April 08, 2019

ADDENDUM NO. 1

#15036 – FORD FIELDS CONCESSION STAND BEAUMONT, TEXAS

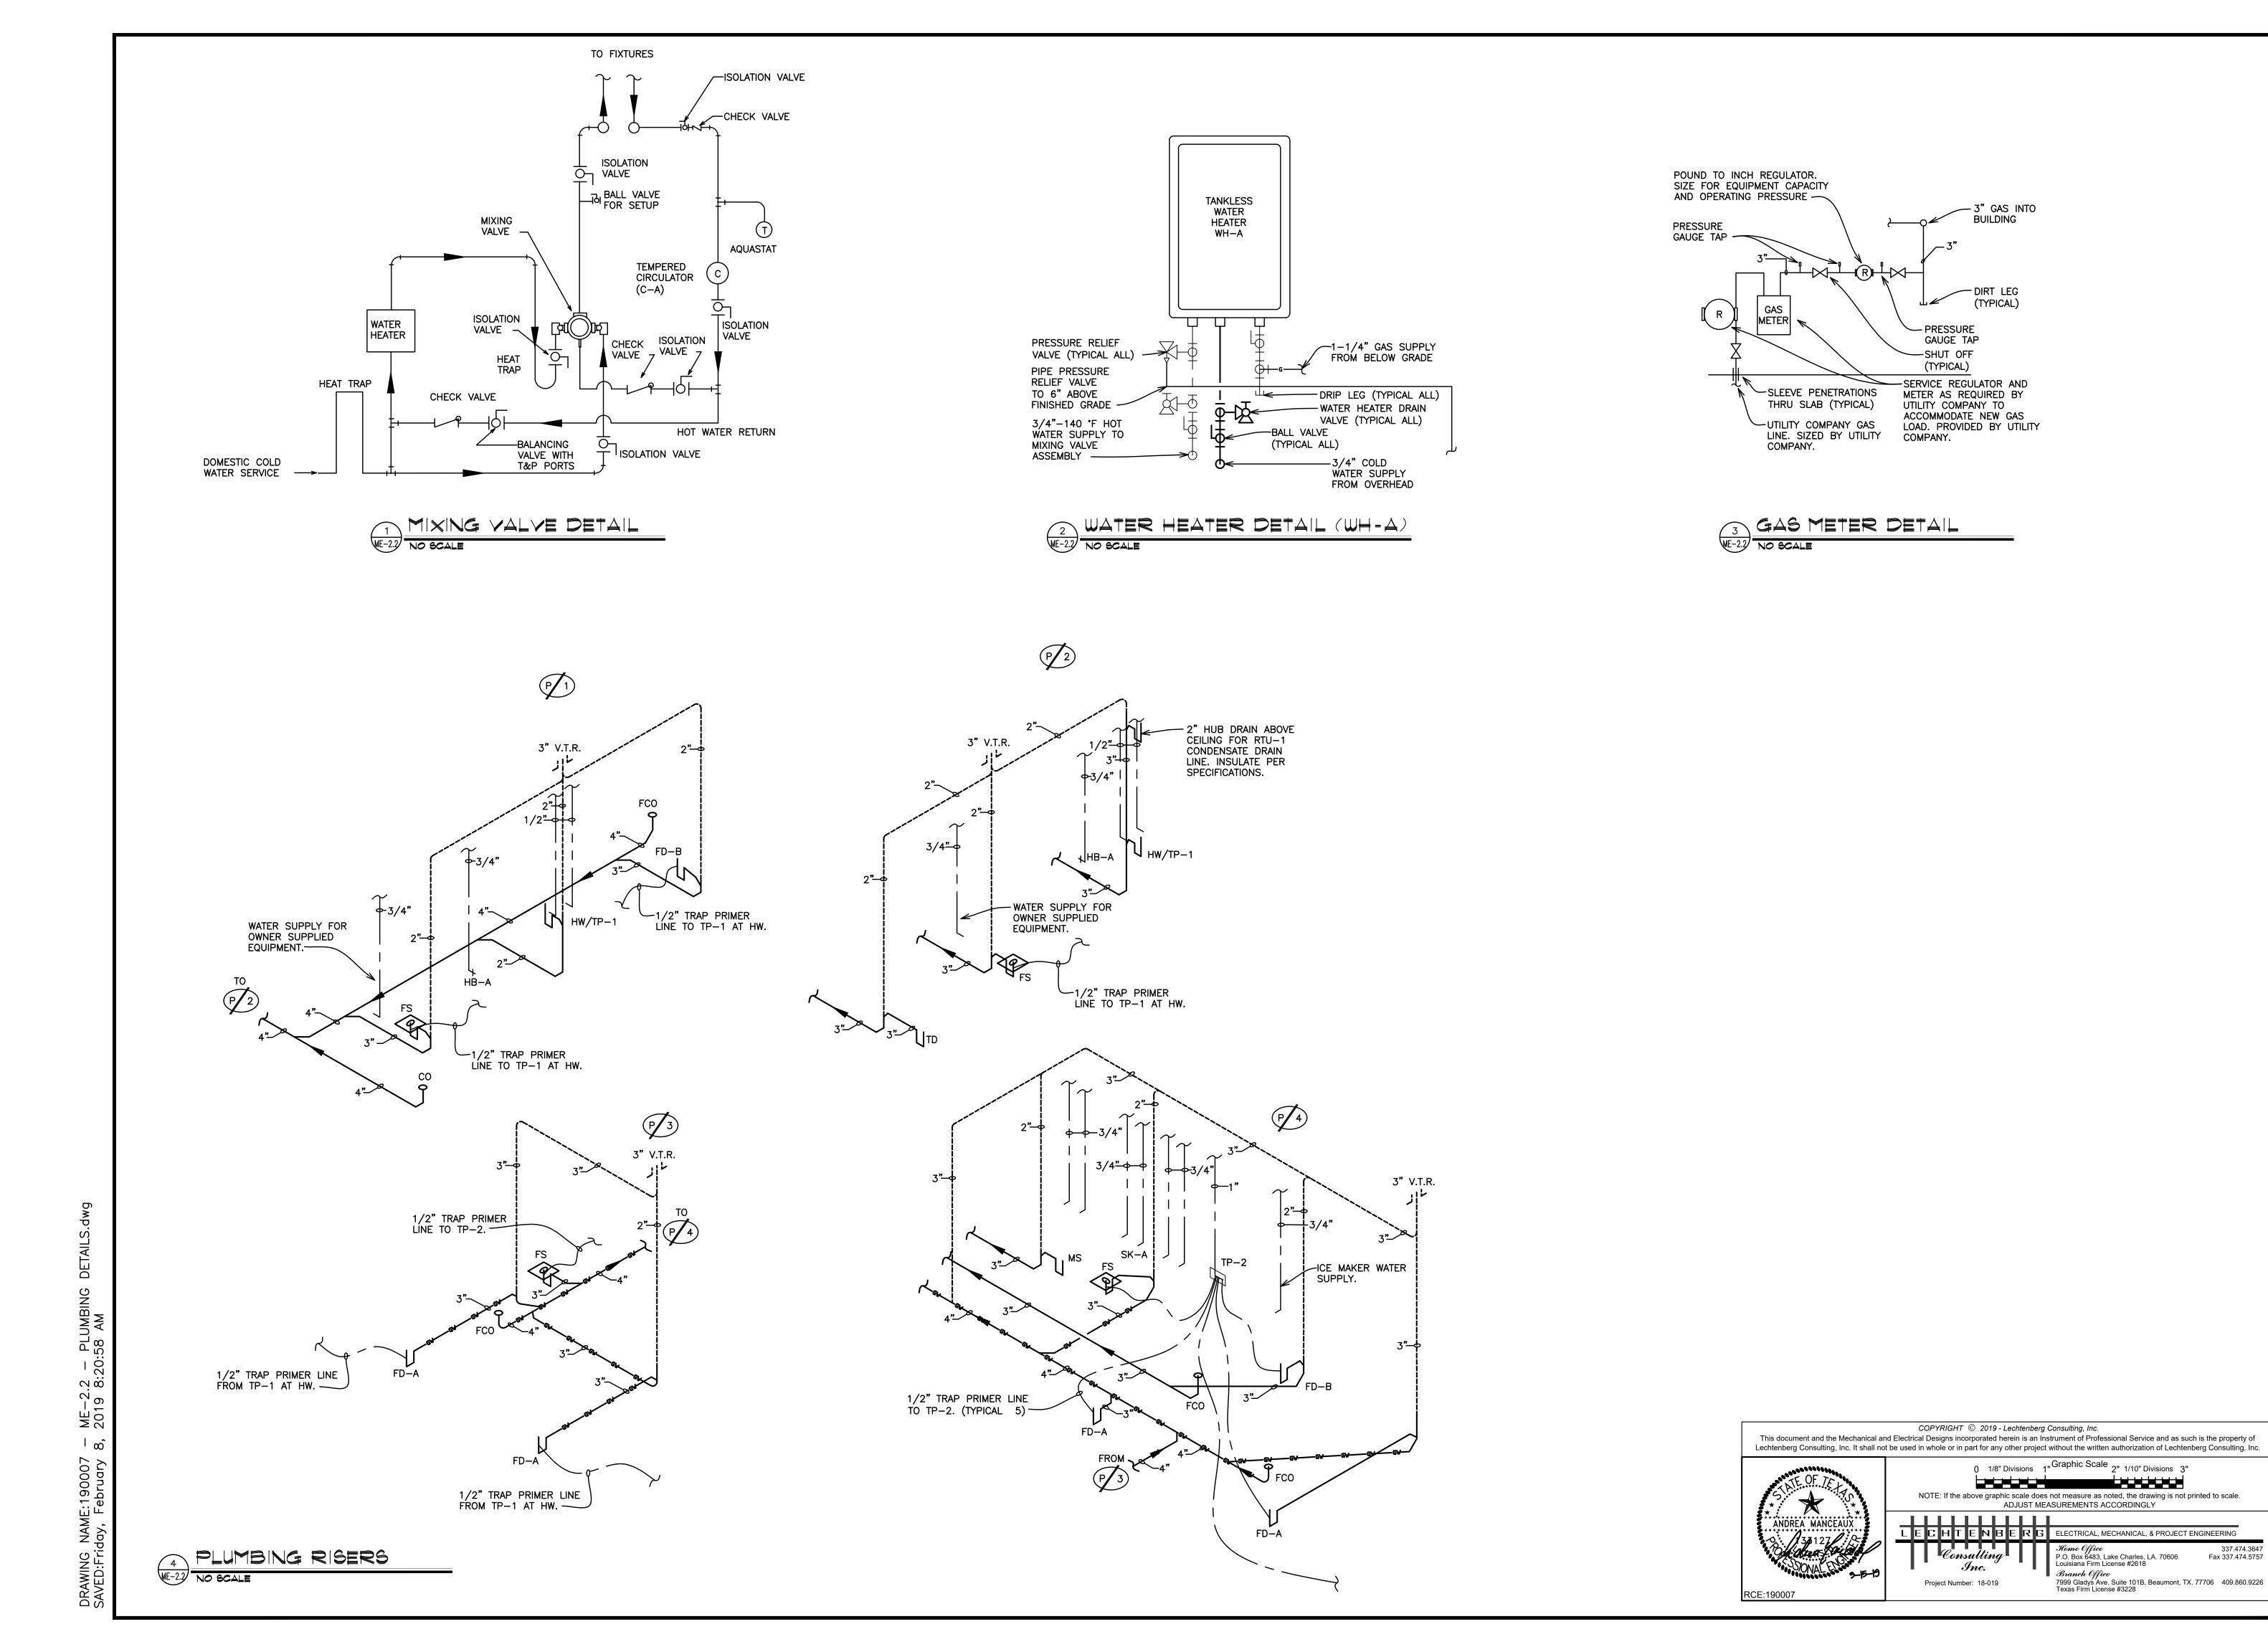
- 1. 2/A1.1 Equipment Schedule Item #34 Notes Delete note in its entirety and revise to read as follows: "Supplied by Owner, Installed by Contractor".
- 2. 2/A1.1 Equipment Schedule Item #35 Notes Delete note in its entirety and revise to read as follows: "Supplied by Owner, Installed by Contractor".
